**Walton County
The Grove**

**Change Proposal #30
Softball Backstop Pole Design
Change & Credit**

Change Proposal #30 – Softball Backstop Pole Design Change & Credit

BACKSTOP LAYOUT (PERSPECTIVE VIEW)

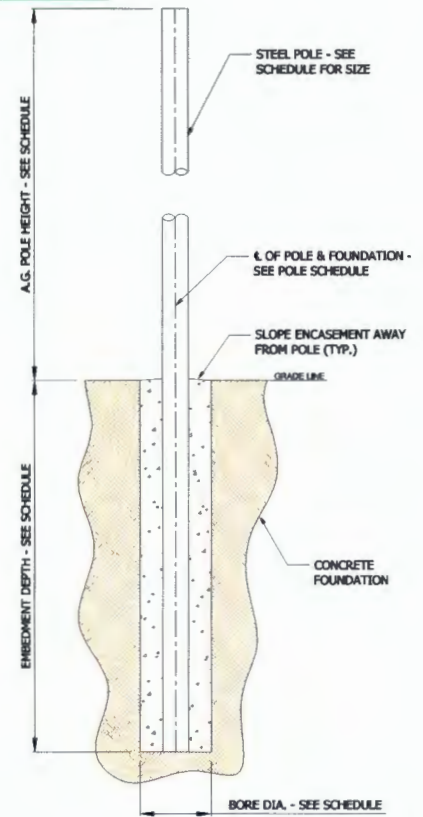
NETTING TO TERMINATE AT 10' BACKSTOP FENCING. DETAIL BELOW FOR REFERENCE ON CONNECTIONS. SEE PAGE 13 FOR REFERENCE.

Backstop posts to be offset from the chain link fencing and posts. See pictures below for reference.
